**TECHNICAL COMMITTEE ON THE
ONGOING MAJOR AND MEDIUM
IRRIGATION PROJECTS IN KERALA**

FINAL REPORT

KERALA STATE PLANNING BOARD

AUGUST 2018

Figure 2 Cut-off diagram of the Banasurasagar irrigation project

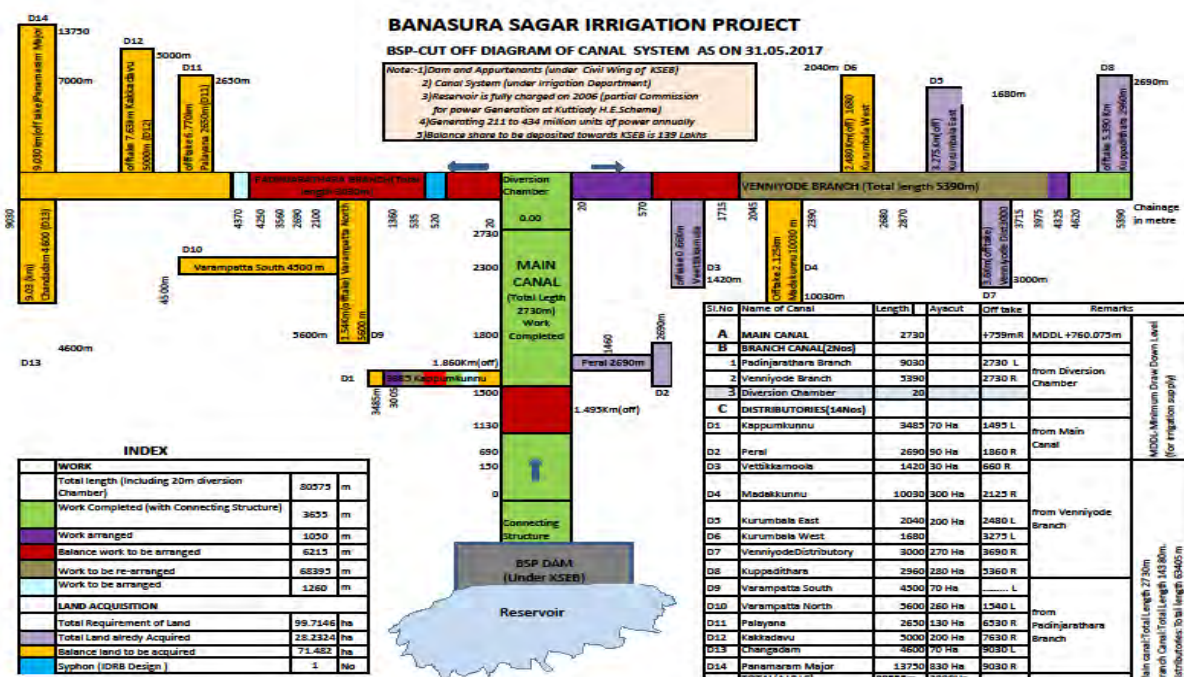
Work on the Padinjarathara branch canal has only been partially complete from 20 m (when the branch canal actually begins after diversion) till 4250 m (see Figure 2). The fully completed stretches within the branch canal are: (a) from 43.50 m till 174.60 m; (b) from 1486.40 m till 1536.90 m; and (c) from 1545.40 till 1561.40 m. This constitutes a total length of aqueducts of about 197.60 m. This apart, work on another 181.70 m has also been completed under cut and cover or flume (a) between 2093.60 m and 2185.30 m; and (b) between 2407.80 m and 2497.80 m. The rest of the work is largely in the nature of partial constructions of mass piers and trestle piers.

There are two major bottlenecks in the Padinjarathara branch canal. The first bottleneck is between 543.30 m and 568.30 m. The Padinjarathara-Kuppadithara road was constructed by the panchayat across the alignment of the branch canal after the design of the branch canal was approved. As a result, the Irrigation Department has suggested a new syphon-based design for the branch canal to cross the road. This new design, which is absent in the original design, has been sent for approval to the IDRB, but the approval has not yet been received.

The second bottleneck is between 2100 m and 2690 m. In the original design of the branch canal, the portion from 2100 m to 2515 m (415 m) was proposed to be covered flume and from 2515 m to 2690 m (175m) was proposed to be open flume. This work was assigned in 2006 to M/S Chandragiri Construction Company and was to be completed in 18 months from February 2007. However, in an unfortunate incident, there was a landslide accident at the site on the 26th of January 2008 in which three workers died. After examinations of the site by the Chief Technical Examiner, the government decided to terminate the contract with M/S Chandragiri Construction Company under the risk and cost of the contractor. The Chief Engineer (P1) has since then submitted a new proposal that has two components: (a) dismantling the partially constructed covered flume at 2100 m; and (b) proceeding with the balance work between 2100 m and 2690 m consisting of covered flume and open flume. This new proposal was submitted as per the suggestions made by the Technical Sanction Committee of Chief Engineers held on 09-03-2015. Technical sanction for this new proposal was received (vide order number D5-

(a) The approval for the revised syphon-based design of the Padinjarathara branch canal needs to be urgently accorded by the IDRb and the work has to be completed at the earliest.

(b) Work on the Padinjarathara branch canal may be terminated at the site of the accident viz., at 2300 m. In our view, dismantling the partially constructed portions of the branch canal and completing construction of the branch canal up to 2690 m is an extremely complicated and difficult task to achieve. Moreover, our analysis of the command area in the Padinjarathara branch canal network shows that the area that could be irrigated is also likely to be small (see Figure 4).

(d) Between 20 m and 2100 m in the Padinjarathara branch canal, the department should explore the construction of maximum numbers of sluices to ensure that water can be diverted into the natural waterways on either sides.

Figure 13 *Cut-off diagram for the left bank canal of the Muvattupuzha Valley Irrigation Project (MVIP)*

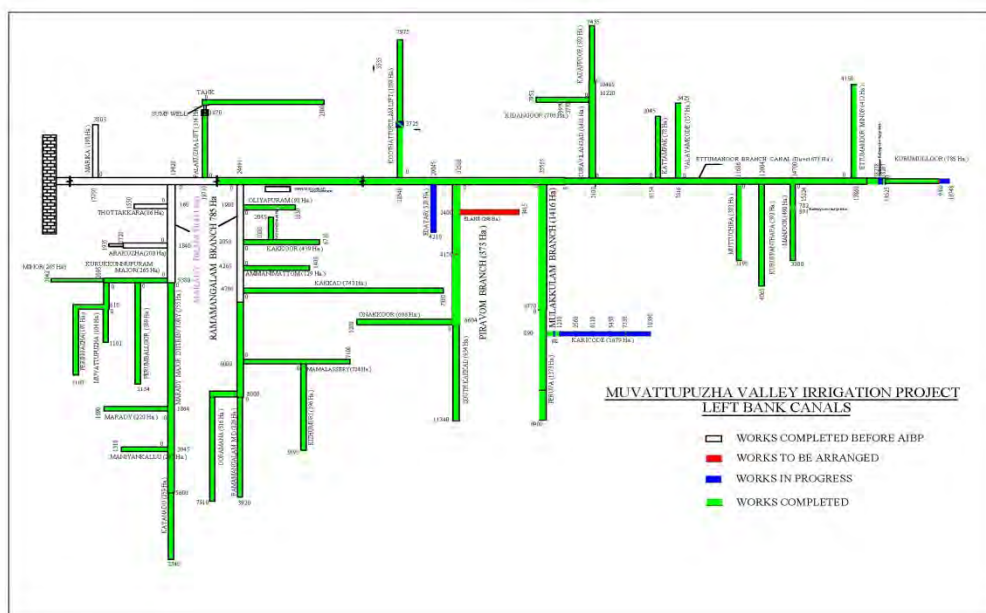
The Ezhuthonippadam aqueduct was to be constructed over a railway line at chainage 18275 m between the Kuruppanthara and Ettumanoor railways stations. This is a very short stretch over a single line in the LBMC (see Figure 13). The government had entrusted the work to the Kerala Irrigation Infrastructure Development Corporation Limited (KIIDC) in 2016. However, to begin work on the aqueduct, temporary staging work was to be completed by the Ministry of Railways. For this purpose, an amount of Rs 1,17,92,773 was remitted to the Ministry in 2008 itself. When the Technical Committee visited the MVIP site in January 2018, the work was still pending for want of the completion of various formalities and availability of materials. If the Ezhuthonippadam aqueduct is complete, an additional 786 ha of land can be brought under irrigation in the panchayats of Manjoor, Kanakkari, Njeezhoor and Athirampuzha.

The Karikkode distributary is located in the Mulakkulam branch canal of the LBMC (see Figure 13). There are many minor issues that have accumulated in this distributary.

- Between chainage 1210 m and 2560 m (second reach), a revised estimate became necessary, as rock portions were found to be larger. The project office submitted such an estimate to the government in 2015; responses to queries raised were submitted in 2017. According to documents submitted to this Committee, the revised estimates are about 25.21 per cent higher than the original estimate. However, the contractor has done blasting work beyond the agreed quantity. The contractor has not been paid because the revised estimate has not yet been approved. Hence, the work has been stopped. **The**

- Between chainage 5430 m and 7330 m (fifth reach), another revised estimate has been made necessary. In this case, the project office has passed on the revised estimate (14.11 per cent above the original estimate) to the office of the Chief Engineer, but it has not been passed over to the government for final approval after responding to all clarifications requested by the government. **The Technical Committee recommends that this revised estimate be urgently considered and passed on merit by the government at an early date.**

Technical Committee recommends that this revised estimate be urgently considered and passed on merit by the government at an early date.
